**THE KENNECOTT EAGLE
MINE PLANNED FOR UPPER
MICHIGAN IS PREDICTED
TO BE
UNSTABLE.**

August 2010

JACK PARKER AND ASSOCIATES, INC.

The Kennecott Eagle Project

Figure 1

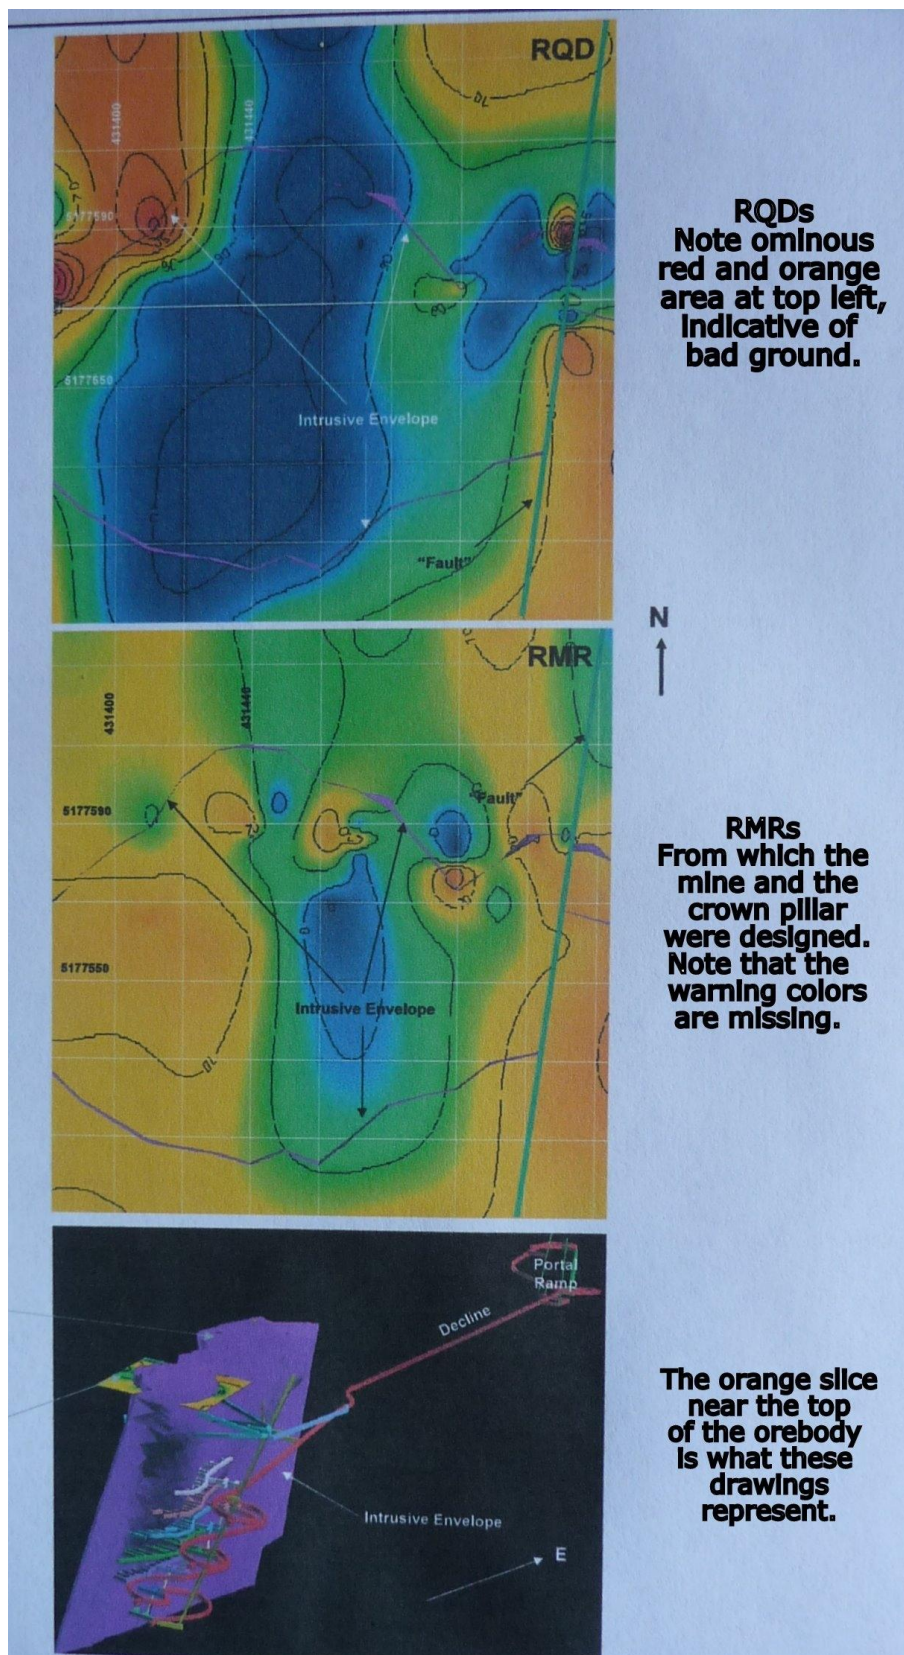
DRAWINGS COMPARING RQDs AND RMRs. Figure 1 is an example. Tabulated values were transferred to drawings at the location of the drill holes. Contours (lines of equal value) were then interpolated between holes. Then the areas between contours were color-coded, from red to show poorest conditions to green and blue showing the best.

Note immediately that the contours around the red holes are close together – “bull’s-eyes” – implying that their influence is local, not widespread. The contours between blue/green holes are far apart, implying that the good conditions *are* widespread. That, of course, skews the information toward favorable conditions.

Figure 1 illustrates the point. It represents conditions on a horizontal slice through the ore body, roughly in the middle of the ore body (see lower sketch).

At top left in the upper drawing, RQDs, is a large ominous patch of reds and oranges. This is appropriate, because the cores there are broken and the RQDs are low. Look again at the front cover of this report. Does that look like “solid rock”?

But now look at the middle drawing, RMRs. That ominous red/orange patch does not show up!

Hey! We, like everybody else, had assumed that we were being fed sound engineering information; but now we smell a rat. Existence of the rat was confirmed when we obtained a tabulation of RQDs and RMRs for “our” eight holes. **THE LOW RQD VALUES WERE ON RECORD, BUT CORRESPONDING RMRs WERE MISSING. THOSE LENGTHS OF POOR CORE HAD BEEN OMITTED AS IF THEY DID NOT EXIST. MINE PLANNERS, REGULATORS AND OUTSIDE REVIEWERS ALIKE DID NOT NOTICE THE DECEPTION. It is subtle and clever, although not especially smart.**
